Addendum No. 2

**For Project No. ENG2209631441
Ferdinand Campground Improvements
Ferdinand State Forest
Ferdinand IN.**

ISSUED FROM: Division Asset Management & Engineering

FOR AGENCY: Department of Natural Resources

ADA Parking for Van

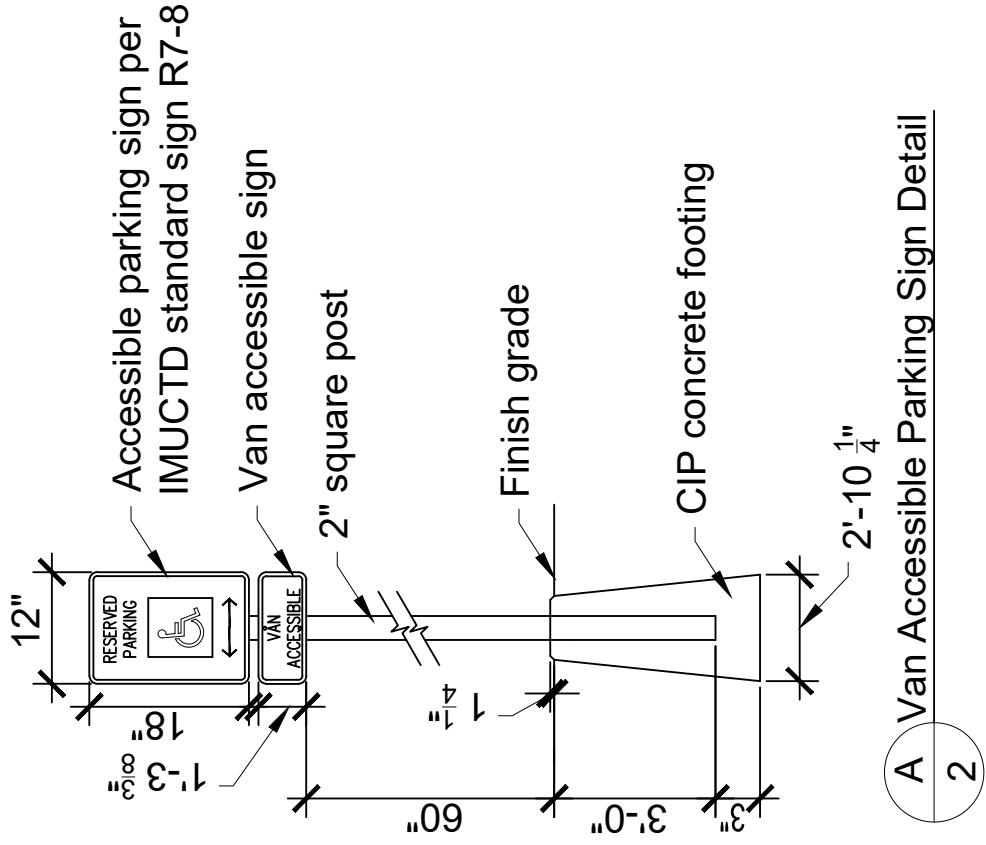
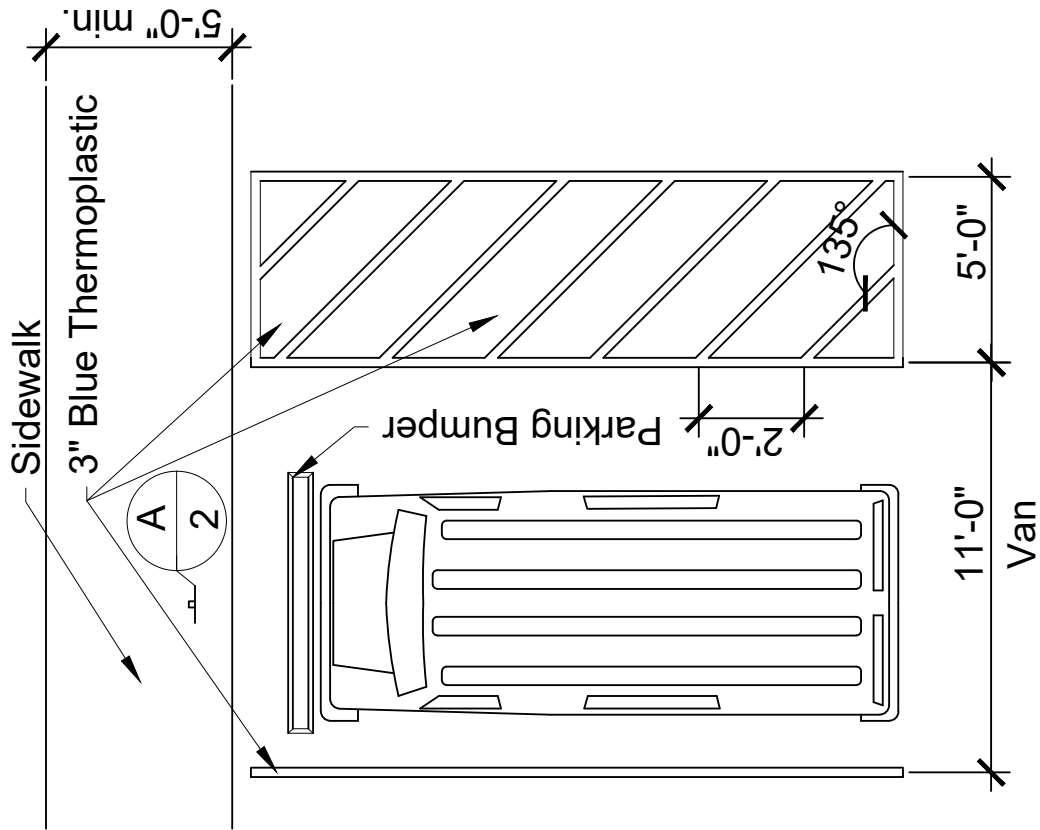
ITEM No. 2: ADA PLAN FOR VAN PARKING

A. Standard detail and dimension for ADA van parking.

SIDEWALK DETAIL
SCALE: NTS

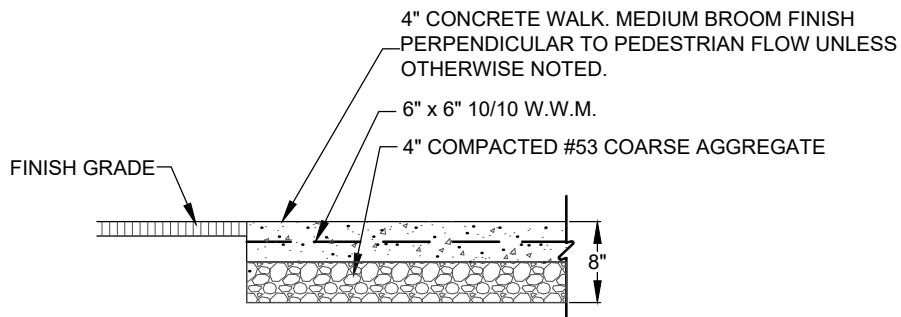
ITEM No. 3: CONCRETE DETAIL

A. Concrete sidewalk detail

Transverse Slope Shall Not Exceed 1:50. Longitudinal Slope Shall Not Exceed 1:20.

Full Depth Separators Are Not Permitted Except At Expansion Joints.
